寄件者: Louis Tse <[REDACTED]>  
寄件日期: 2026年05月27日星期三 16:33  
收件者: tpbpd/PLAND  
副本: David Chi Chiu CHENG/PLAND; Ivan Sze Yuet FUNG/PLAND; Bon Tang; Matthew Ng; Christian Chim; Danny Ng; Grace Wong  
主旨: [Supersede][FI] S.16 Application No. A/YL-KTN/1231 - FI to address departmental comments  
附件: FI1 for A\_YL-KTN\_1231 (20260527).pdf  
類別: Internet Email

**Temporary Warehouse (Excluding Dangerous Goods Godown) and Open Storage of Construction Materials with Ancillary Facilities and Associated Filling of Land for a Period of 3 Years in "Agriculture" Zone, Various Lots in D.D. 107, Fung Kat Heung, Yuen Long, New Territories**

**(S.16 Planning Application No. A/YL-KTN/1231)**

**Responses-to-Comments**

DWG. TITLE  
FSIs PROPOSAL

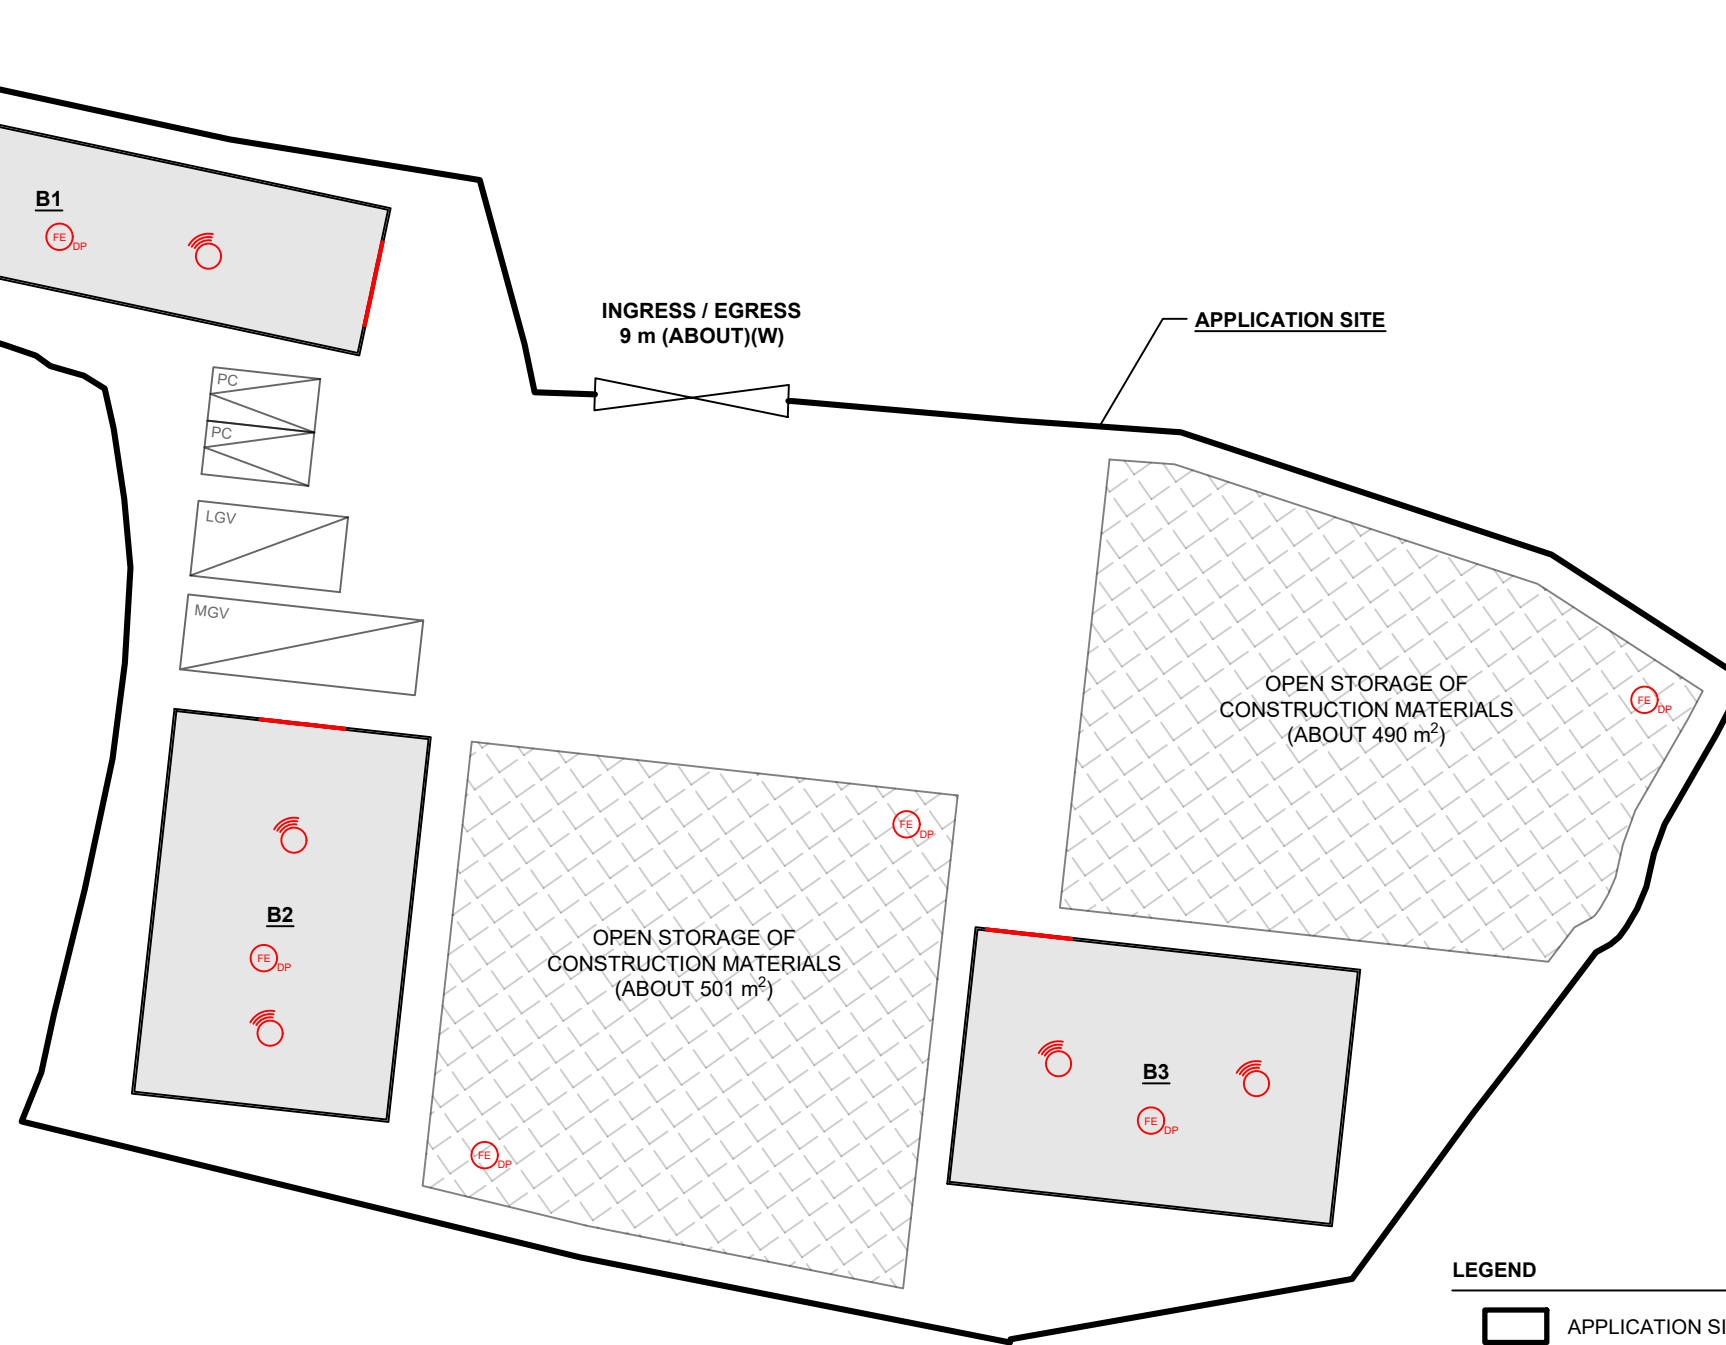
3. Comments of the Director of Fire Services (D of FS) (Contact Person: Mr. WONG Cheuk-kei; Tel: 2733 7737)		
(a)	For enclosed structure with gross floor area not exceeding 230 m <sup>2</sup> , portable fire extinguisher and stand-alone fire detector shall be provided;	Noted and revised accordingly. Please refer to the revised fire service installations proposal for details ( <b>Annex I</b> ).

(b)	In relation to item (i) above, if two or more stand-alone fire detectors are installed in an enclosed structure, all detectors shall be interconnected (either wired or wirelessly) such that when one of the detectors is triggered, all connected detectors shall sound an alarm simultaneously;

(c)	Stand-alone fire detectors shall be provided in accordance with the “Stand-alone Fire Detector General Guidelines on Purchase, Installation & Maintenance [Sep 2021]”;

1. POTABLE HAND-OPERATED APPROVED APPLICATION SHALL BE PROVIDED AS REQUIRED BY OCCUPANCY.
2. SUFFICIENT STAND-ALONE FIRE DETECTOR SHALL BE PROVIDED THROUGHOUT THE ENTIRE BUILDING IN ACCORDANCE WITH THE "STAND-ALONE FIRE DETECTOR GENERAL GUIDELINES ON PURCHASE, INSTALLATION & MAINTENANCE [SEP 2021]".
3. IN RELATION TO 2. ABOVE, WHERE TWO OR MORE STAND-ALONE FIRE DETECTORS ARE INSTALLED IN AN ENCLOSED STRUCTURE, ALL STAND-ALONE DETECTORS SHALL BE INTERCONNECTED (EITHER WIRED OR WIRELESSLY) SUCH THAT WHEN ONE OF THE STAND-ALONE FIRE DETECTOR IS TRIGGERED, ALL CONNECTED STAND-ALONE FIRE DETECTORS SHALL SOUND AN ALARM SIMULTANEOUSLY.
4. ACCESS IS PROVIDED FOR EMERGENCY VEHICLE TO REACH 30m OF ALL PART OF STRUCTURES.
